UNITED STATES PATENT AND TRADEMARK OFFICE

APPLICATION NO.	FILING DATE	FIRST NAMED INVENTOR	ATTORNEY DOCKET NO.	CONFIRMATION NO.
10/695,038	10/28/2003	Michael James Justin	01052	5708
35467	7590	06/21/2007		
BIOMERIEUX, INC. PATENT DEPARTMENT 100 RODOLPHE STREET DURHAM, NC 27712			EXAMINER NAGPAUL, JYOTI	
			ART UNIT 1743	PAPER NUMBER
			MAIL DATE 06/21/2007	DELIVERY MODE PAPER

Office Action Summary

DETAILED ACTION

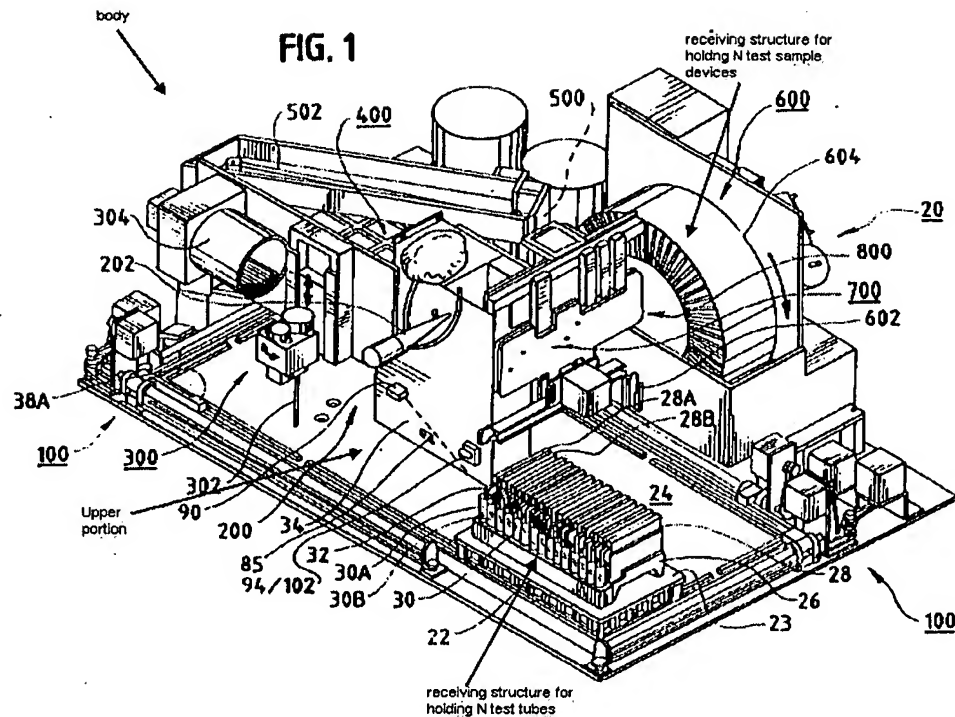
Maes discloses an analytical instrument for conducting biological sample testing. The instrument comprises a carrier/carousel segment (670) for movement of test sample devices/test sample cards. The carrier comprises N optical interrupt positioning features/tabs (691) that is formed in the carrier (670). Additionally, each of the positioning features/tabs (691) is placed in registry with one of the receiving

structures/slots (614). Furthermore, the detection of one of the positioning features/tabs (691) is by a fixed optical interrupt sensor (693) in the sample testing instrument (100) and further detects a position of a test sample device/card placed in the receiving structure/slot (614) corresponding the positioning feature/tab (691). The carrier (670) is moved through the instrument (100) in a direction having a longitudinal axis. The test sample devices/cards are oriented in the carrier (670) in a direction orthogonal to the longitudinal axis. The positioning features/tabs (691) are arranged on the carrier (670) in a direction parallel to the direction of movement of the carrier (604) in the instrument (100). The carrier (670) comprises an upper surface and a lower surface and first and second side regions, and wherein the positioning features comprise voids formed in a rib depending from the lower surface. The rib placed between the first and second side regions. The fixed optical interrupt sensor (693) is positioned in the instrument along the path of movement of the carrier (670) wherein the rib passes over the optical interrupt sensor (693). (See Figure below) Maes further teaches the test sample devices comprises multi-well test sample cards.
